## RESPONSE TO REQUEST FOR ADDITIONAL INFORMATION

### APR1400 Design Certification

RAI No.: 255-8285

SRP Section: 03.08.05 – Foundations

Figure 1. Variation of Shear Modulus with Shear Strain for Sands

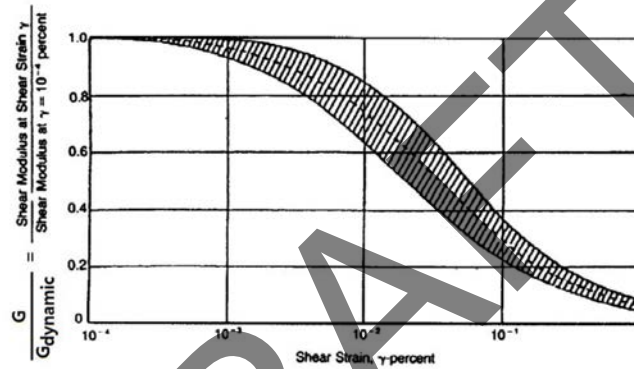
4. APR1400-E-S-NR-14006-P, Rev.1, Section 2.2.1 indicated that the relationship between Elastic and  $E_{dynamic}$  at the soil site is 0.1153. This ratio appears to be extremely low and is probably due to the questions raised in Item (a) and (b) above. The applicant is requested to update the approach to calculating  $E_{static}/E_{dynamic}$  and confirm the adequacy of the resulting ratio based on other sources of information and industry practice.

According to in ASCE 4-98 C.3.3.2.2 and Seed & Idriss (1970), the shear modulus with shear strain level for sand varies as shown in Figure 1. Here  $G_{dynamic}$  is the dynamic shear modulus at very low strain (less than 0.0001%) and  $G_{dynamic} = \rho V_s^2$ . Figure 1 demonstrates the reduction of shear modulus with strain level for sand and the typical variability in the relation. Generic data from the many field and laboratory test results supported the nonlinear behavior of soil with strain level.

Since the value of  $E_{static}/E_{dynamic}$  from Seed-Idriss curve is 0.23 and this value is larger than 0.1153 from SPT blow count related equation, use of  $E_{static}/E_{dynamic} = 0.1153$  from SPT blow count is a conservative approach.
